Accessibility Audit

Westfield Primary School

Clayton Crescent,

19/06/2020

Appendix 68

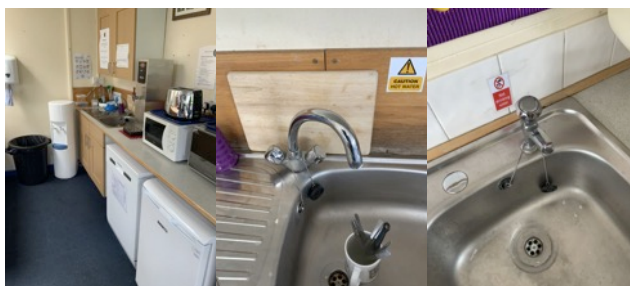
<p>14.8 - Do staff and general kitchenette areas have a lever tap to accommodate people with dexterity impairments? Are there split height work surfaces available? Are there lever taps within the classrooms?</p>	<p>D</p>	<p>The kitchenette within the staff room does not feature lever taps to aid people with dexterity impairments. There are also no split height work surfaces to aid wheelchair users and people of short stature. The taps within the classrooms should be changed to lever style.</p>
---	----------	---
